# CORDIA MEDAN

## Project Site Visits ~ Aceh

### Leprosy Communities at Trienggadeng and Po Diamat Villages

By  
Sjoerd Nienhuys, Architectural Engineer  
Shelter Advisor, Trócaire (Ireland)

Kitchen Extension at Rear of House

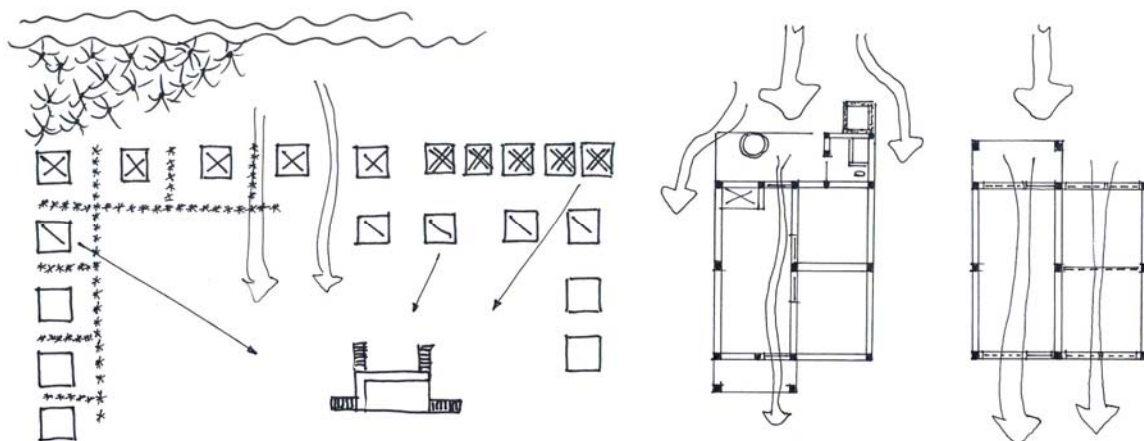
The 59 houses, some with wheelchair ramps for the disabled, are almost completed. It has been decided to add a kitchen on the rear platform of the houses, next to the WC, because the occupants (ex-leper patients) would have no financial means to realise this themselves. The kitchen extension has been designed with a wooden post and a masoned wall. The timber roof support has been fixed with a nail into the plaster of the house. However, with an earthquake, this will come loose immediately. In addition, the joint between masonry and timber post will always remain visible.

*The kitchen extension should be made by using a masoned wall with an infill stiffener column of 10 cm x 10 cm (instead of the wooden posts). Over the top of the wall, a reinforced concrete stiffener beam 10 cm x 6 cm thick should be cast with two 10 mm bars. These two bars need to be connected into the reinforced columns of the building by opening the concrete and filled in after attachment.*

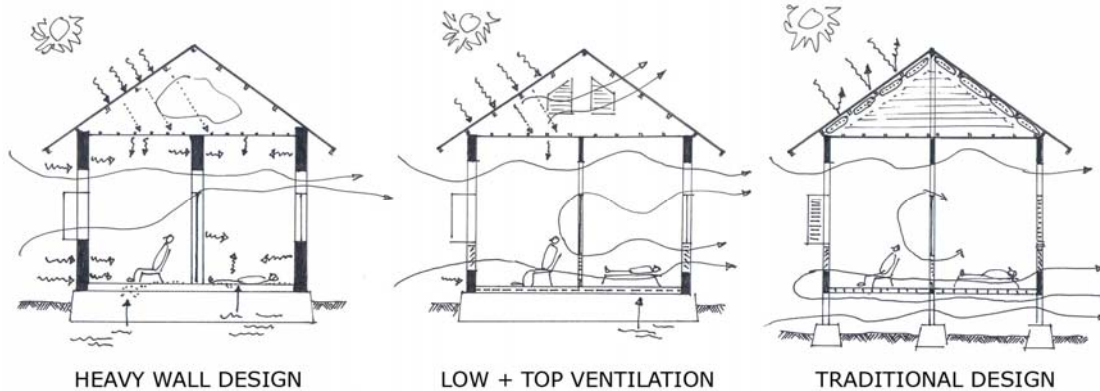
The reinforcement of the foundations in the above photos (houses very near to the Aceh east coast) is not adequately covered with good quality concrete. In addition, the plastering will not provide sufficient protection against the salty sea air. Such construction quality will self-destroy due to corrosion.

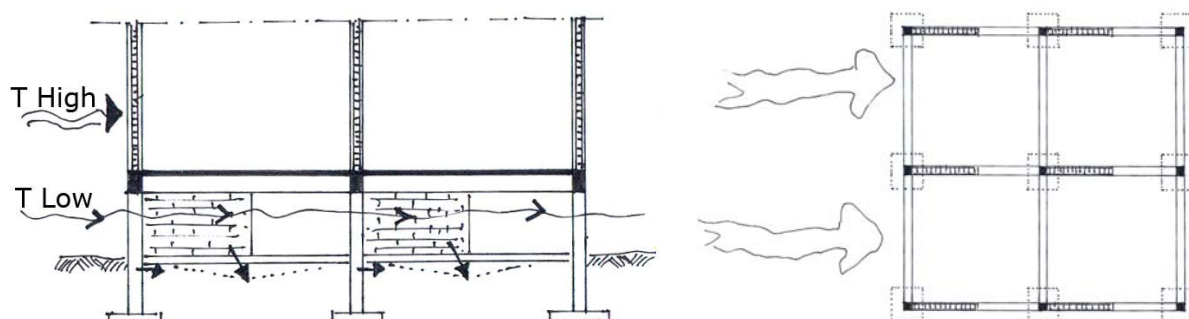
The coastal soil in Po Diamat between the surrounding fish tanks has shifted regularly over the years and is rather sandy. While the 13-column structure seems to be adequate, the footings under the columns are only 60 cm x 60 cm, giving doubt to their bearing capacity in the sandy soil. During a prolonged earthquake, the sandy soil can easily settle under the small footings, with a destructive result. Neither the heavy floor ring-beams nor the 12 cm thick reinforced concrete floor may be able to withstand the settlement of a few columns and crack. The one-meter depth of the column footings, however, is adequate against scouring by moving water.

*The column footings on the sandy soil along the coast should be minimal 80 cm x 80 cm.*

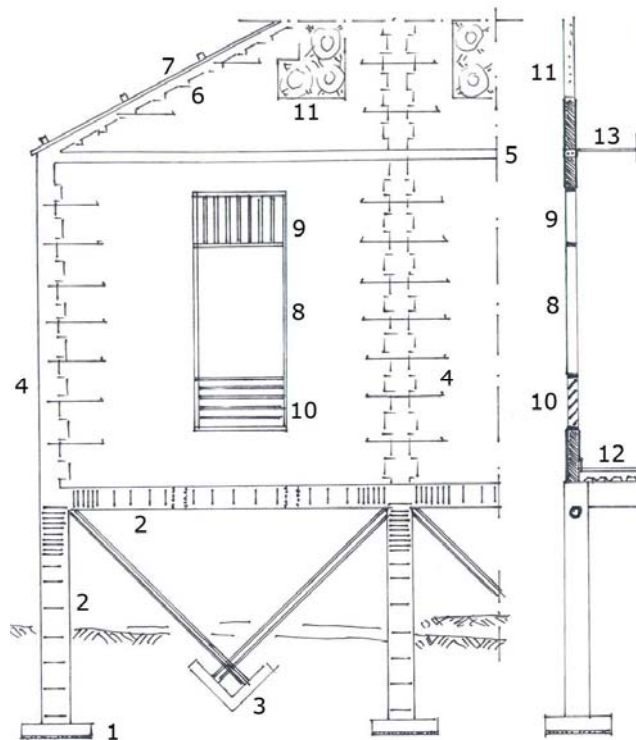
If another tsunami hits higher than the floor level of these houses on stilts, the bottom columns will not be able to withstand the horizontal pressure (load) and break off under the ring-beam because the tsunami load is about 10 times greater than an earthquake force.

*To resist another high tsunami that reaches above the elevated floor level, bracing walls or supporting diagonals should be placed between the stilt columns.*

The above sketch illustrates an additional support wall built under the floor and against the columns, in the direction of the land. The foundations of these bracing walls need to be adequate to receive a vertical load without the risk of settling.

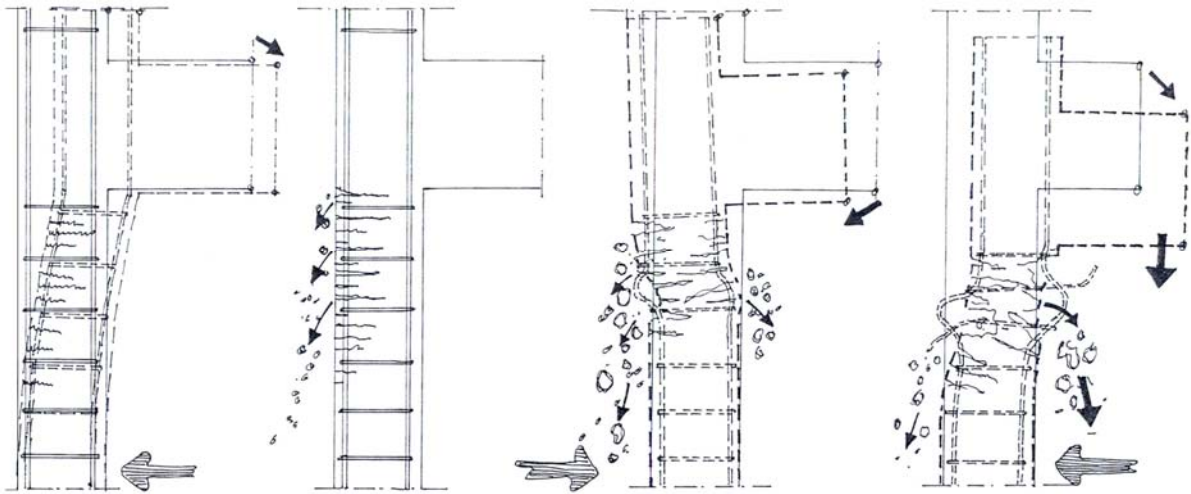
The foundation columns continue structurally into the columns of the first floor. In one construction site (left photo below), the reinforcement bars stop about one meter above the floor level, while the second contractor (right photo below) has placed the complete vertical reinforcement as one piece. Although the later requires some temporary support, this design is better as it does not require overlapping of the reinforcement bars in the base of the columns above the floor, thus saving steel reinforcement.

For a smooth concrete reinforcement bar to work properly, the bar needs to be anchored over a length of minimal 50 times its diameter in the concrete before it can develop its planned strength. In the overlap section, additional stirrups need to be placed. For cold deformed bars, the minimal overlap is 40 times the diameter. In addition, both bar types need end-hooks.

*The reinforcement of the columns should be in one piece, where possible, to minimise overlaps.*

Typical Column Failure – No Stirrups

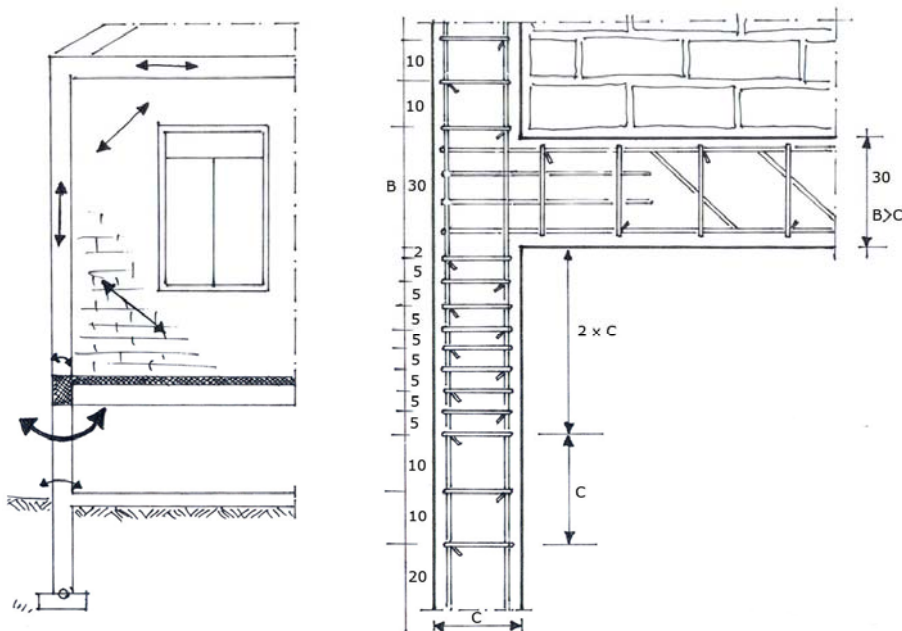
Observation on photo – page 12 (bottom right): At the vital maximum moment zone, there were insufficient stirrups. As a result, the concrete crumbled and fell out during an earthquake. The sketches below explain the process of failure during one shock. In reality, a series of shocks occur during an earthquake, continuing the described process and resulting in the column collapsing and with that bringing the house down.

Each column end should be reinforced with a cage of stirrups at its maximum moment zone to avoid broken concrete from falling out of the construction when earthquake forces exceed the design forces. This is especially the case when the floor beams are stronger than the columns. The column ends should therefore have 6 mm stirrups every 5 cm over a length of minimal 1.5 times the column width under the floor beam, followed by two stirrups 10 cm apart and then continuing with stirrups every 20 cm for the rest of the column.

The sketch on the left shows the forces that occur in the current structural design. Only the stilt column is subject to a strong bending moment, while the upper column and tie-beam only receive compression and stress forces when the infill wall remains intact. In such a case, the reinforcement pattern sketched on the right is recommended. Better still is when the floor beam is lighter or thinner than the column, shifting the possible failure area to the beam.

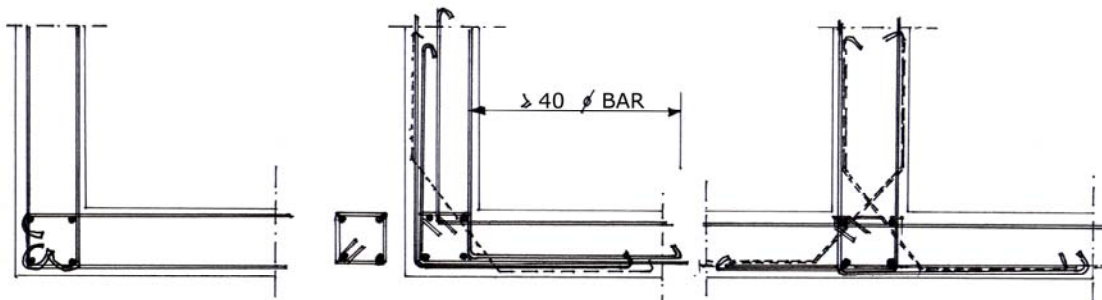
Observation: The eight reinforcement bars in the beam are not going around the 90° corner into the other horizontal beam section, but instead end with hooks inside the column. The eight hooks in the column, coming from two directions, totally congest the space inside the column. When casting the column with concrete, air pockets will be created. Because of the inadequate length of the hooks, the junction will be far below the required structural strength. The situation is aggravated in two other corners because two additional bars were added.

The reinforcement design of the ring beams should be detailed showing the reinforcement bars going around the corner, instead of ending with hooks inside the columns.

Left Sketch: Illustrates the applied reinforcement. In reality, four bars were applied in both the upper layer and bottom layer of the beam.

Middle Sketch: Illustrates the correct application of the beam reinforcements. These go through the column, around the corner and end in a hook, providing minimal a 40 bar diameter overlap. The possibility exists to add another diagonal bar (dotted line) depending on the force calculations. In the areas of the maximum moment, in the beam as well as in the column, additional stirrups should be placed with 5-6 cm spacing.

Right Sketch: Illustrates the same principle for a T-junction.
